Comment from AMO

Archaeological Heritage

寄件者: Enrico Wong <[REDACTED]>
寄件日期: 2025年11月19日星期三 15:03
收件者: Brian Ching Hong CHAN/PLAND
副本: Timothy Wai Pui WU/PLAND; William Shu Tai WONG/PLAND; Johnny Chung Yin LAM/PLAND
主旨: Re: [Departmental Comment] Planning Application No. A/NE-LK/165 --- Proposed Temporary Holiday Camp (Private Tent Camping Ground) for a Period of 3 Years in "V" Zone, Shek Chung Au, Sha Tau Kok
類別: Internet Email

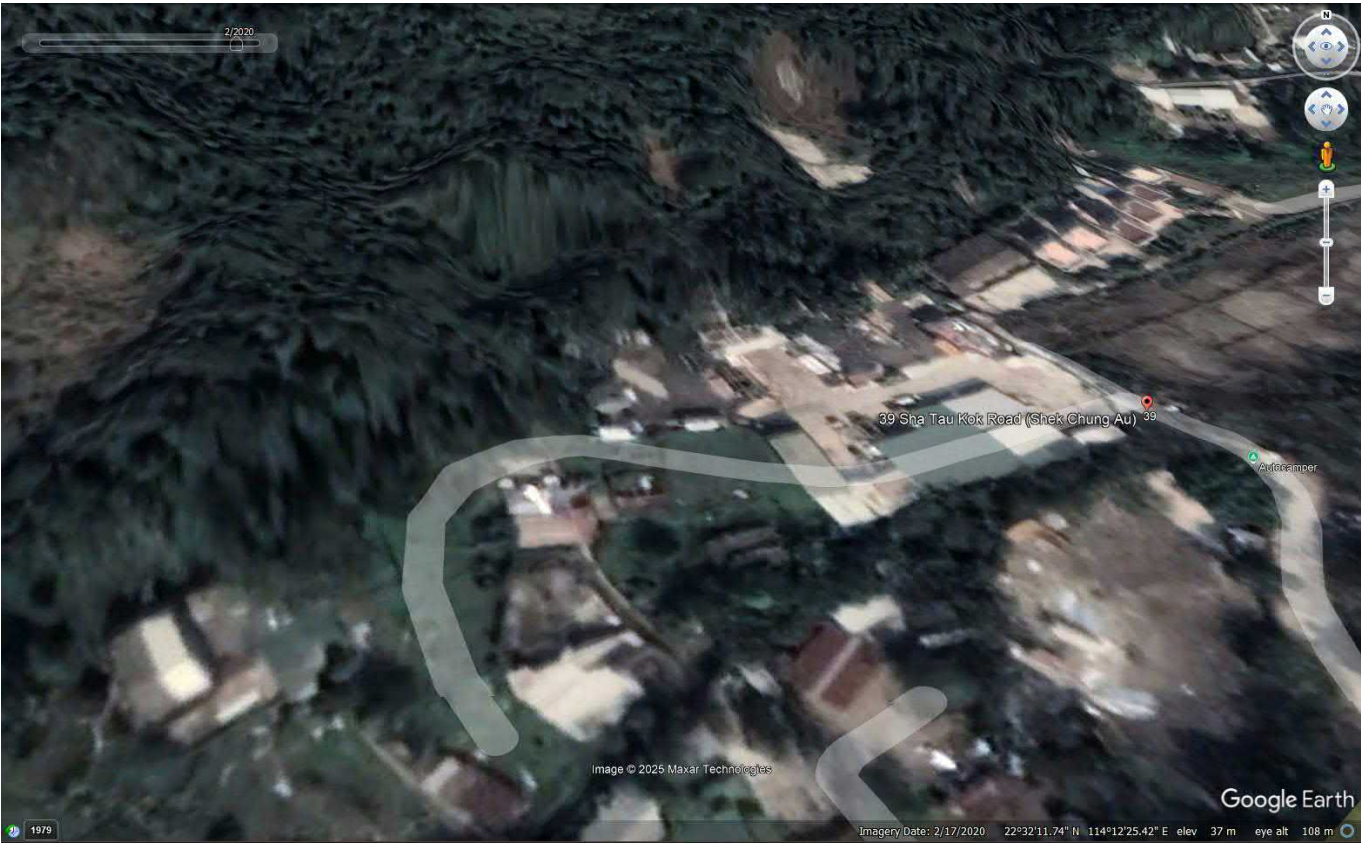
1. The Applicant is aware of the site location within SAI and the AMO's concern. Hereby provide further information and grounds to support the Applicant's view that no adverse impact would be done to the SAI:

- b. The Application Site is located on the eastern border of the SAI, furthest to the centre of discovery of the SAI and among clusters of storage buildings, including those still existing and some demolished over the years. Please see attached location map 1 and 2.

- e. Attached please find the google earth image of the site from 2020 to 2022:
- i. 02/2020: Buildings/Storage structures can be seen covering all over the site. It is believed to be used as a logistic operation centre. For such operations and construction of the structures, a very high extend of land excavation and formation was likely to be made.

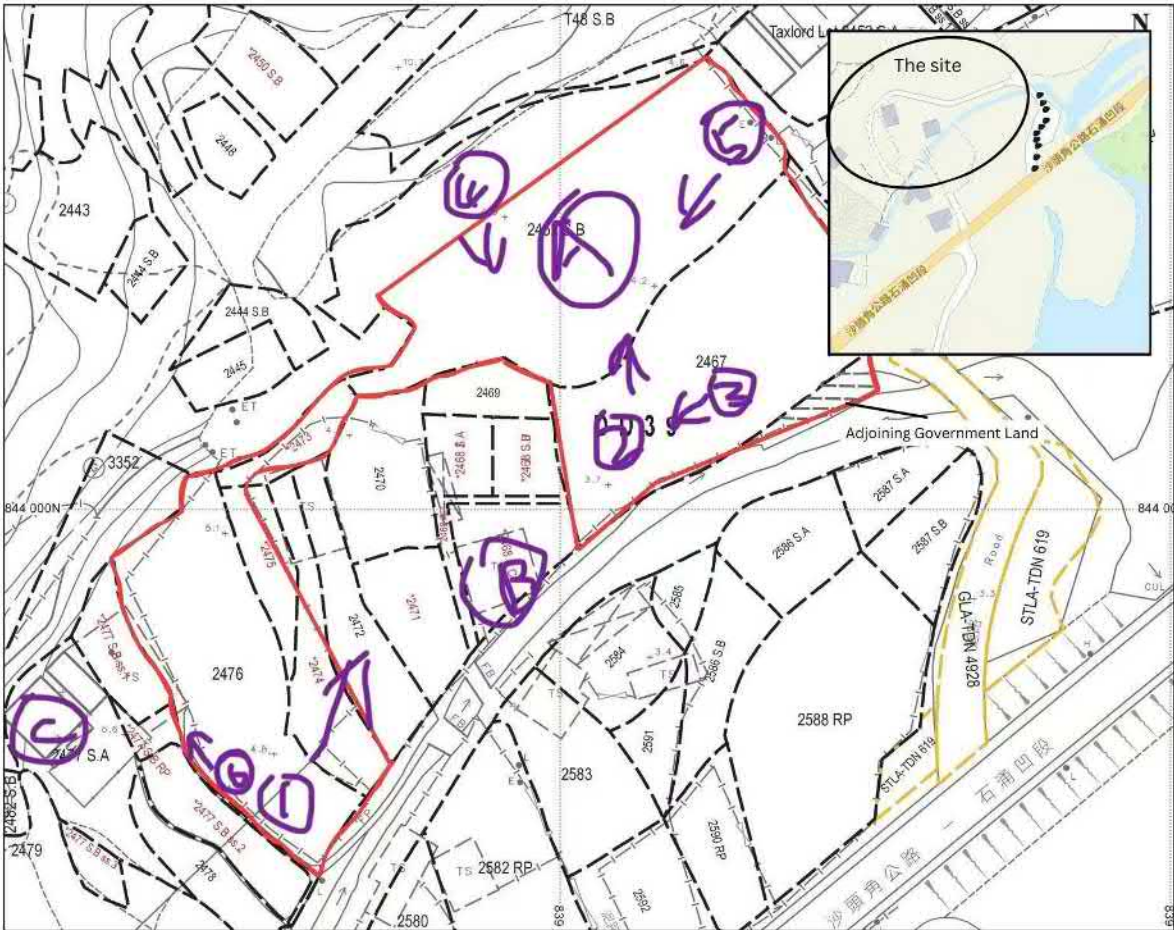
Further to the previous reply to AMO's comment, the Applicant would like to supplement more photos collected from various villagers for AMO to access the archaeological potential of the site:

The photos 1-5 are believed to be taken sometime between 2019 to 2021 where the storage/logistic development / cease-of-development on the site took place.

The Applicant has tried to reference and mark the location, reference objects and direction of view of the photos for the AMO's easy reference. Please see the attached Direction-of-view plan.
